Disability Access Review

Client:	St Vincent de Paul Society C/- Bhavna Arumugam (barumugam@epmprojects.com.au>
Prepared by:	In Square Building Consulting Pty Ltd
Job Address:	182 Young Street, Waterloo
Development:	Internal alterations to the existing Frederic House residential care building to facilitate an additional sole occupancy unit, balcony alteration works and modifications to the ground floor carpark to facilitate storage functions.
Exclusions:	Limited to Scope defined
Reference:	ITS10119.2-ACCESS
Date:	6/03/2026

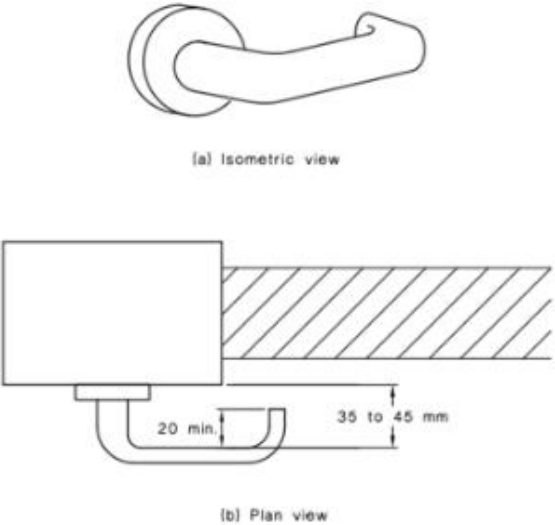
D3D22 Handrails	Does not comply - Material	Handrails do not appear to be achievable along both sides of the passageway or corridor used by residents without reducing the width of the hallways outside of bedroom 61 as required by D2D8 (required 1.5m hallway width and 1.8m width at SOU doorways), handrails are required to be— (i) fixed not less than 50 mm clear of the wall; and (ii) where practicable, continuous for their full length.	It is anticipated that the extent of handrails considerations outside of the units may be resolved at CC stage by performance-based assessment.
